BERTHS 97-109 [CHINA SHIPPING] CONTAINER TERMINAL PROJECT

Final Supplemental Environmental Impact Report (SEIR)

September 2019

Chapter 2 Response to Comments

Figure 1. Comparison of project-level NO_x emissions as represented in the 2008 EIR and 2017 DSEIR.⁴

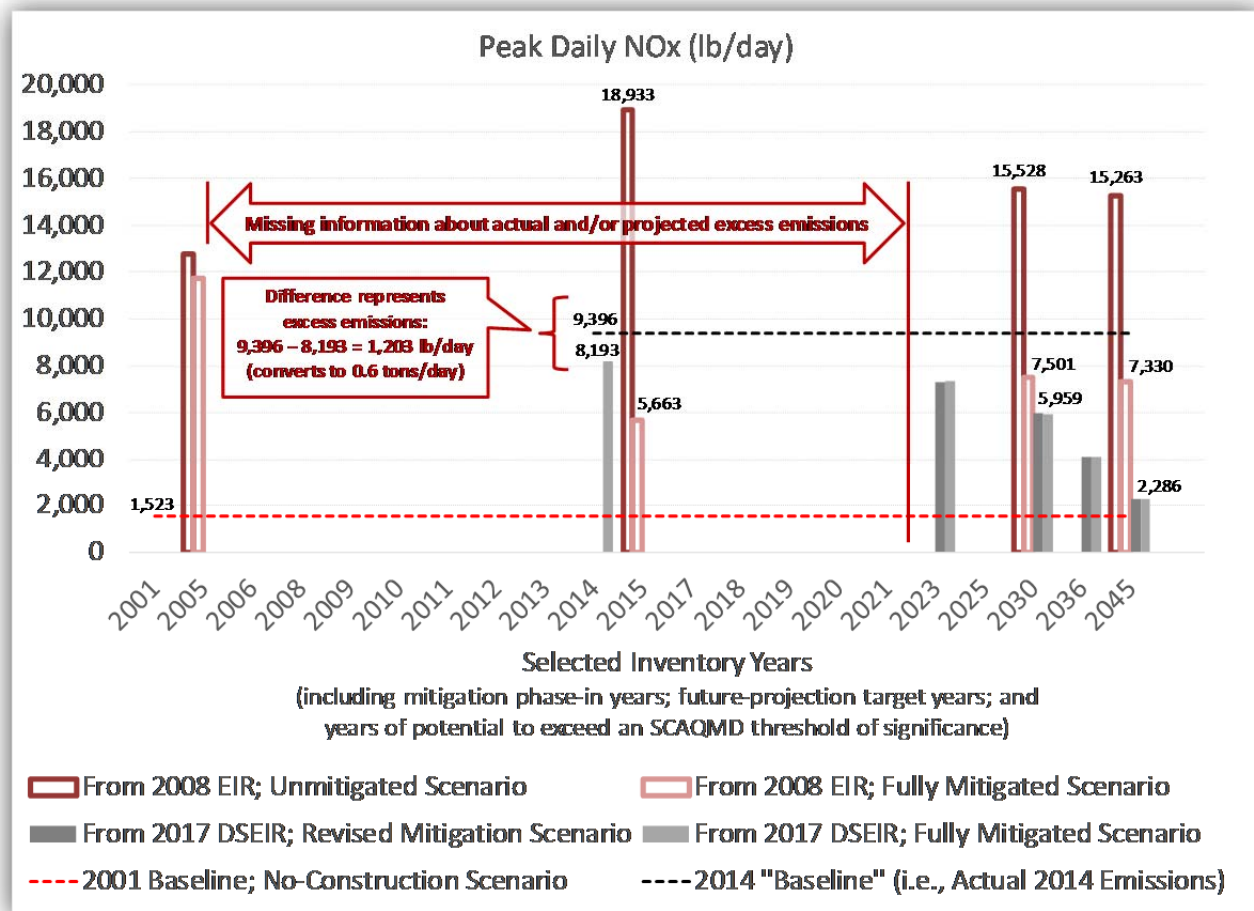
- An inconsistency was found in the 2008 EIR itself when comparing the approved mitigation scenario to the unmitigated scenario. For example, the 2010 NO_x emissions from cargo handling equipment associated with the approved mitigation scenario were actually higher than those for the unmitigated scenario (when clearly the opposite is expected). If the 2008 EIR is selected to be used as a reference to compare scenarios in the future, then further investigation and validation of the 2008 emissions estimates is warranted. (See discussion beginning on page 17 and Figure 12.)

Figure 3. Contributions of major source categories to project-level 2014 annual emissions of (a) NOx, (b) PM_{2.5}, (c) DPM emissions, and (d) PM₁₀ emissions.

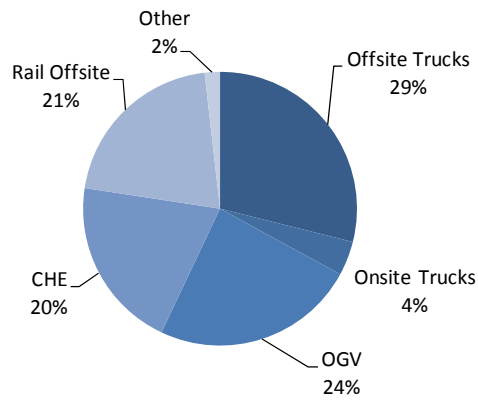
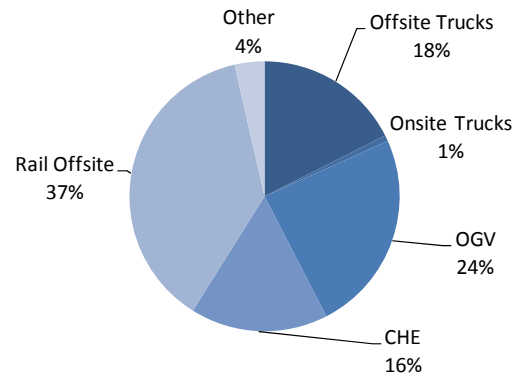
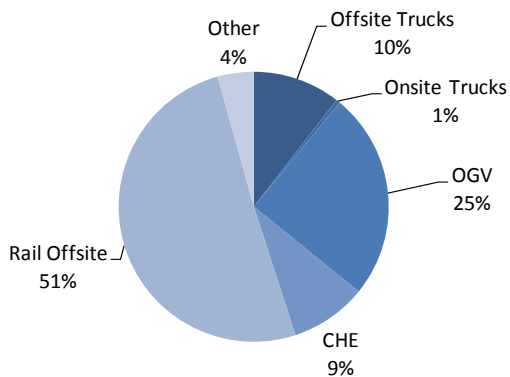
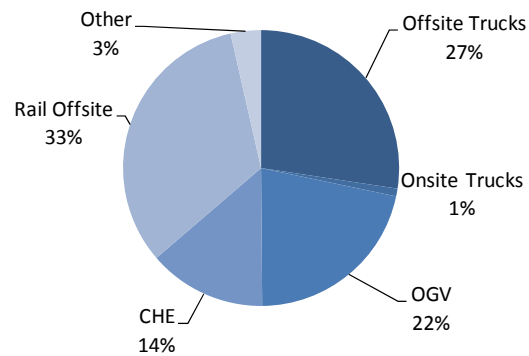
NRDC.I11-17

Figures 4 and 5 illustrate alternative estimates of project-level PM and NO_x emissions for heavy-duty trucks operating within the boundaries of the CS Container Terminal Project. Based on best available information, STI staff working under my direction prepared estimates of annual emissions for two scenarios⁵: (a) implementation of MMAQ-20 as approved (“Estimate - Fully Mitigated Plan” in the figures) and (b) implementation as proposed in the 2017 DSEIR (“Estimate - Relaxed Mitigation Plan” in the figures). These estimates cover several calendar years (2013, 2014, 2017, 2018, and 2023); and they are plotted alongside the analogous emissions estimates from the 2017 DSEIR for year 2023—i.e., the only comparable year covered in the 2017 DSEIR. **STI’s estimates show the excess emissions from heavy-duty trucks occurring, while the information from the 2017 DSEIR either omits (2013-2018) or even suggests no benefit from the approved mitigation plan in 2023.**⁶ Note that by ignoring years earlier than 2023, the 2017 DSEIR takes advantage of an EMFAC-projected conversion of the vehicle fleet in 2023 to modern emissions standards—after which time, diesel and LNG trucks are expected to emit PM at similar rates. In other words, federal or statewide regulations are expected to yield a large drop in PM emissions from diesel vehicles in 2023, regardless of which mitigation scenario is in effect at the CS Container Terminal. However, the lack of NO_x benefits projected for 2023 in the 2017 DSEIR is unsupported. LNG vehicles are known to emit NO_x at a much reduced rate compared to diesel vehicles. However, the **NO_x emission factors used in the 2017 DSEIR for heavy-duty trucks are contrary to published literature.** Not only are the emission factors for diesel-fueled trucks set to be equal to those for LNG-fueled trucks in the 2017 DSEIR, but the NO_x emission factors for heavy-duty trucks increase from 2023 to 2045 (see **Figure 6**). Both of these patterns are contrary to published literature.⁷

The first part of this comment (Figure 3, page 7 and 8) refers to material presented in a previous draft (the DSEIR). That document has been superseded by the Recirculated DSEIR, in which additional analysis years have been added to the air quality analysis and peak-day emissions have been updated; accordingly, this part of the comment is no longer applicable.

Figure 7. Comparison of various peak-day NO_x emissions scenarios for hoteling of OGVs as represented in the 2008 EIR and 2017 DSEIR.⁴

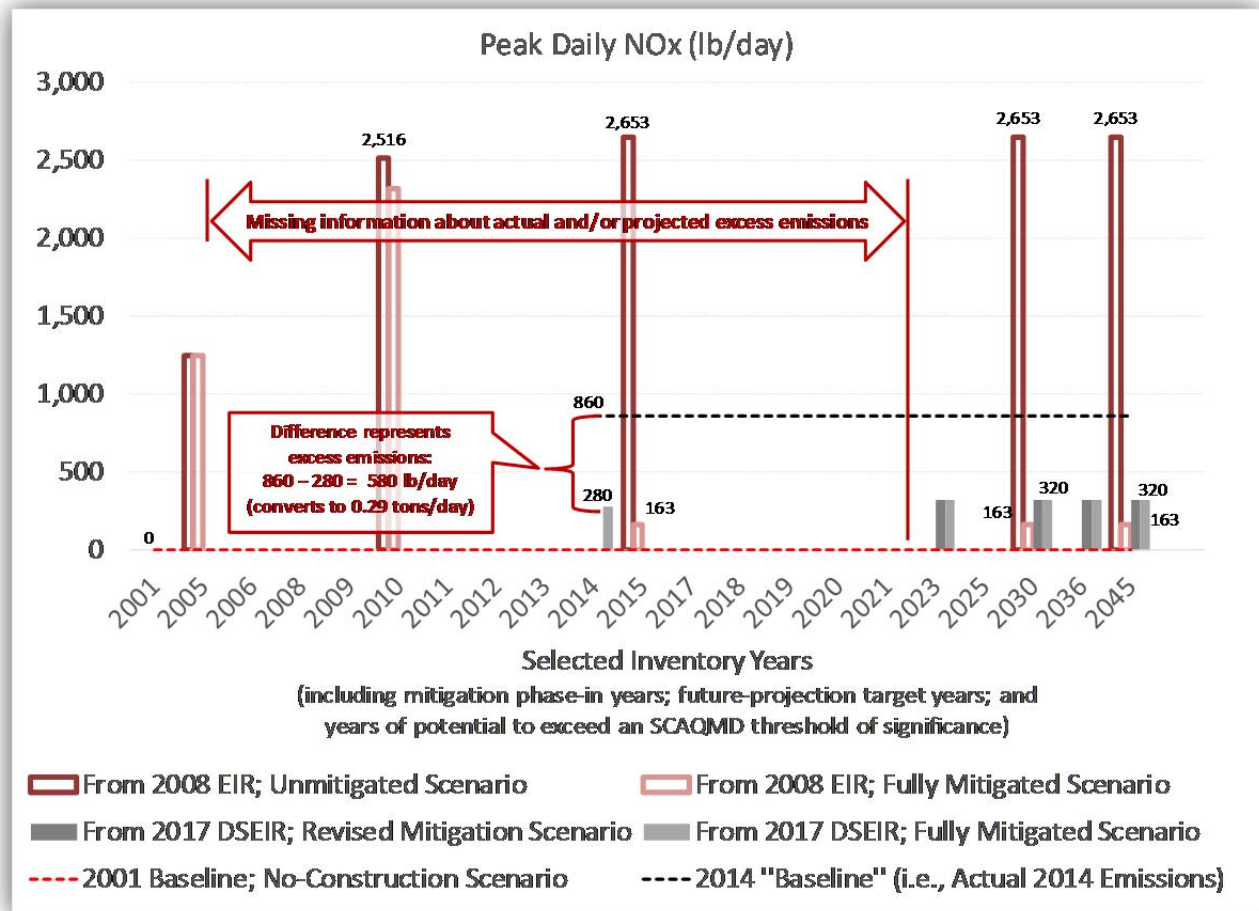
NRDC.I1-19

Figure 8. Comparison of various peak-day PM_{2.5} emissions scenarios for hoteling of OGVs as represented in the 2008 EIR and 2017 DSEIR.⁴

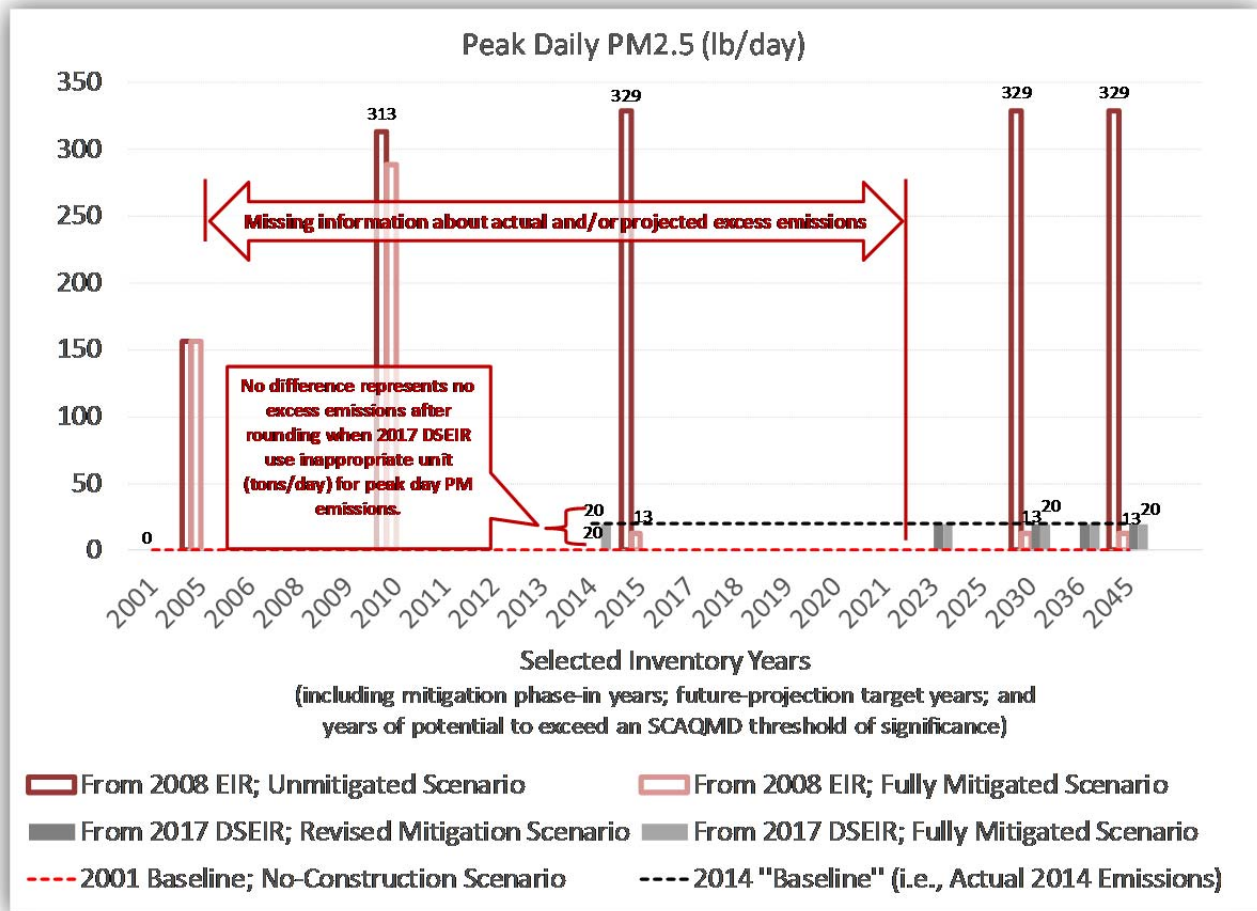
NRDC.I1-19

Figure 9. Comparison of various average-day NO_x emissions scenarios for hoteling of OGVs as represented in the 2008 EIR and 2017 DSEIR.⁴

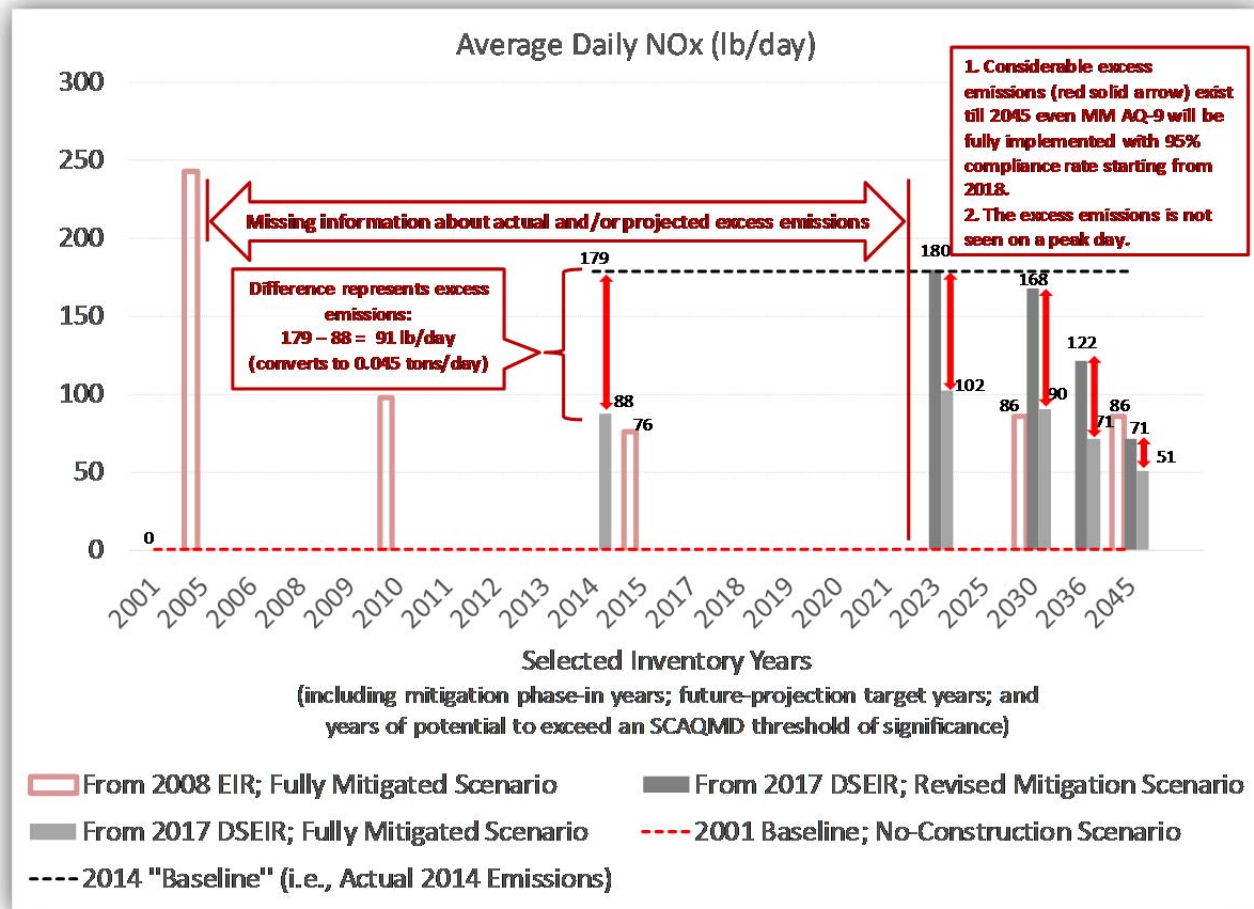
NRDC.I1-19

Figure 10. Comparison of various average-day PM_{2.5} emissions scenarios for hoteling of OGVs as represented in the 2008 EIR and 2017 DSEIR.⁴

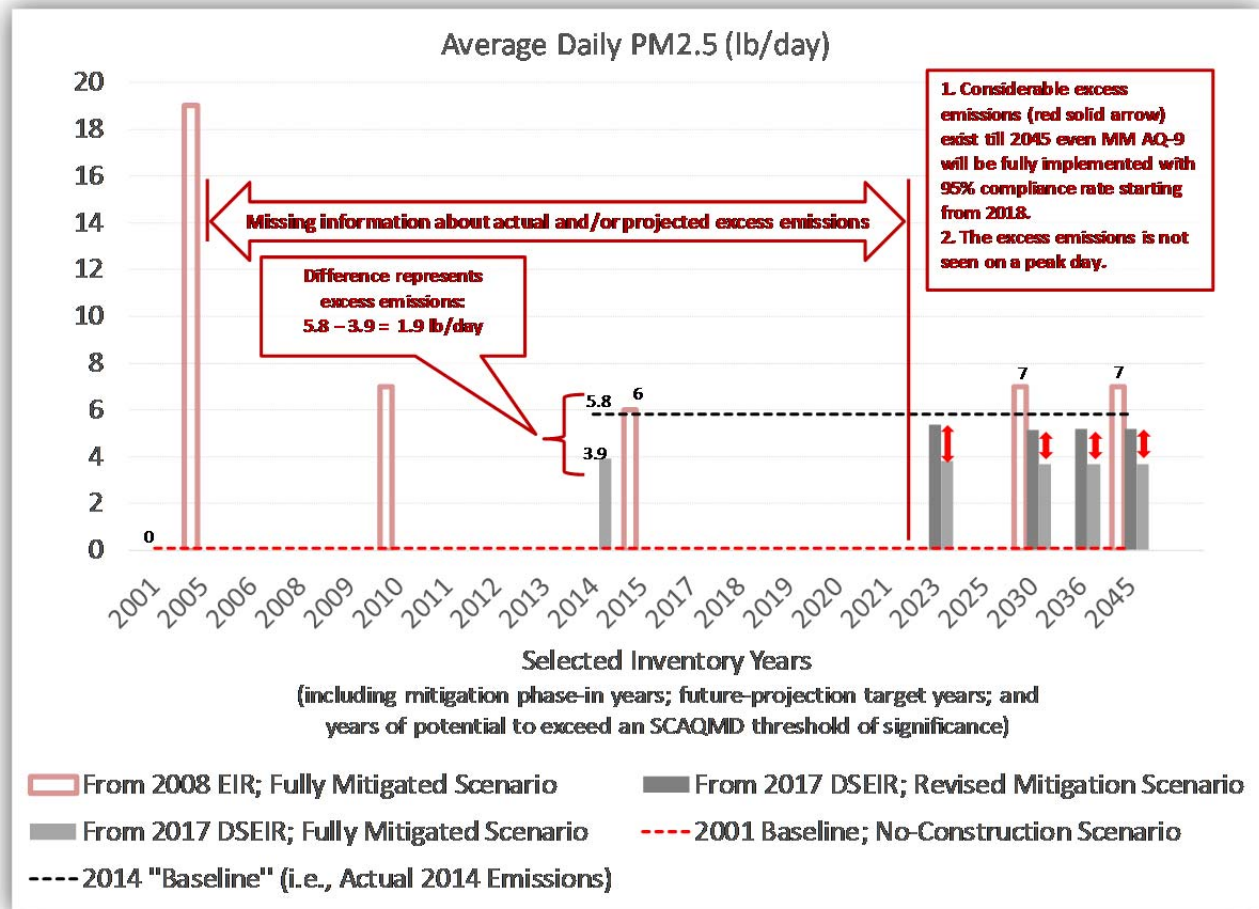
NRDC.I1-19

Figure 11. Comparison of various NO_x emissions scenarios for cargo handling equipment as represented in the 2008 EIR and 2017 DSEIR.⁴

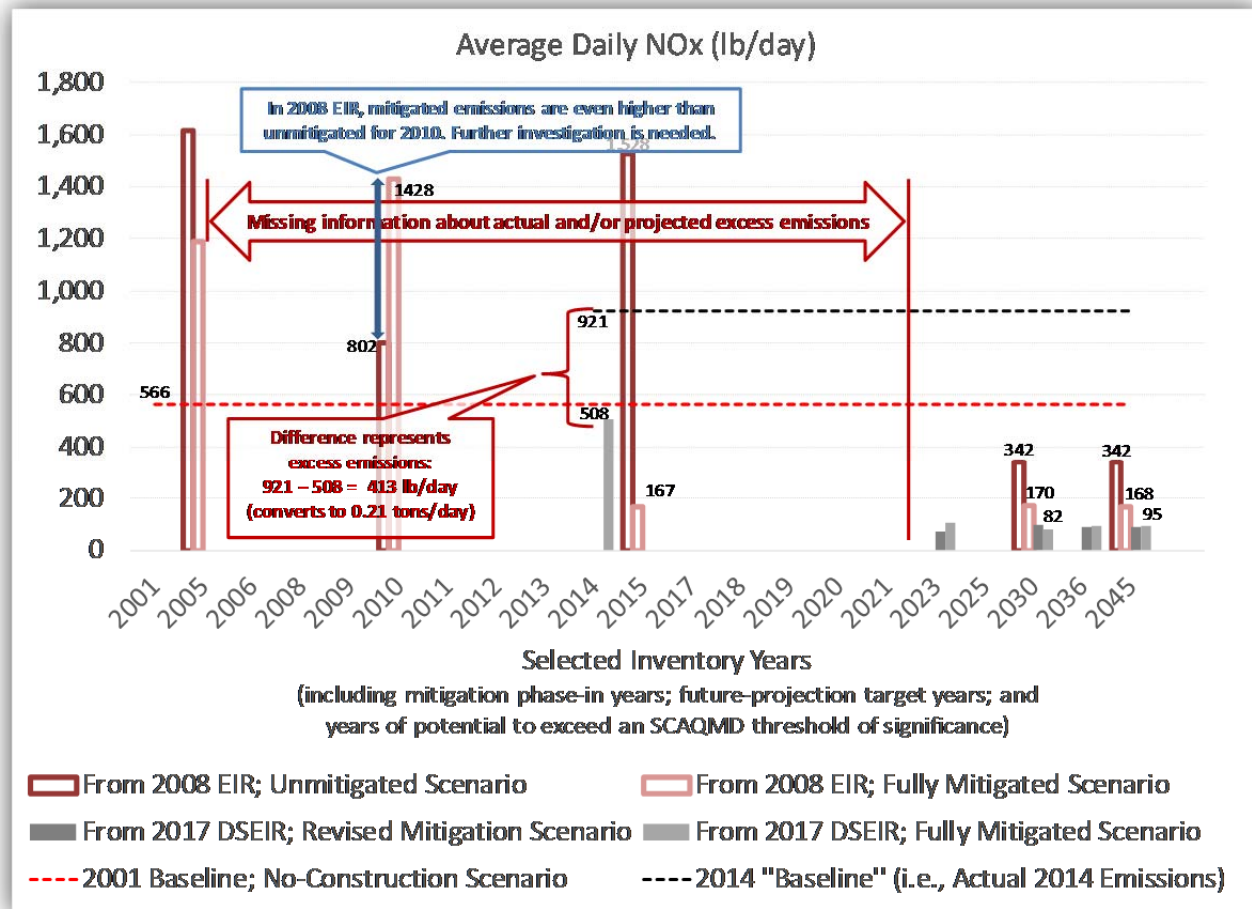
- Figures 11 and 12 illustrate project-level, peak-day NO_x and PM_{2.5} emissions for cargo-handling equipment. An inconsistency issue was found in the 2008 EIR for analysis year 2010 where emissions for the approved mitigation scenario are greater than the emissions for the unmitigated scenario. If emissions from the 2008 EIR are used as a basis for comparison, estimates for these two scenarios need to be verified.

Figure 12. Comparison of various PM_{2.5} emissions scenarios for cargo handling equipment as represented in the 2008 EIR and 2017 DSEIR.⁴

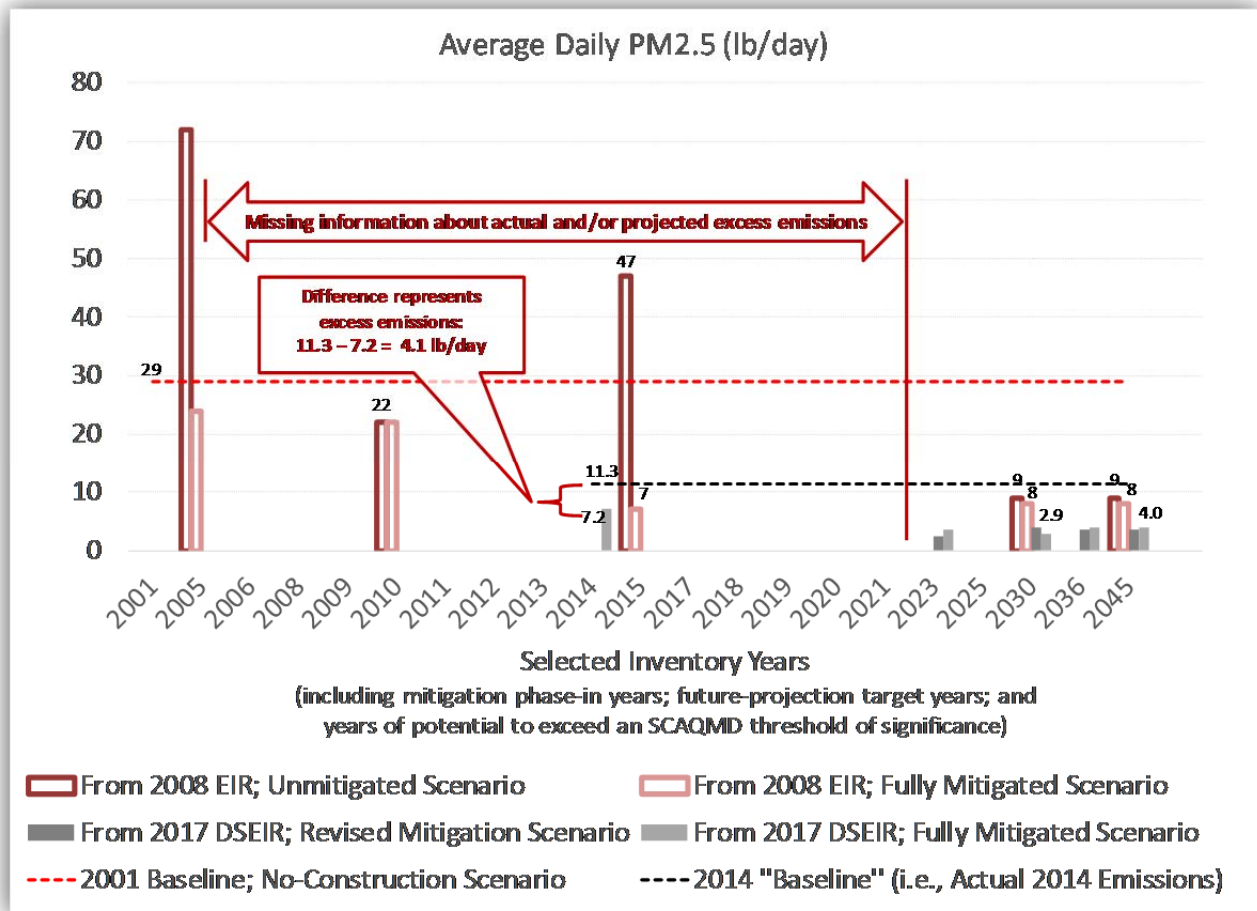
NRDC.I1-20
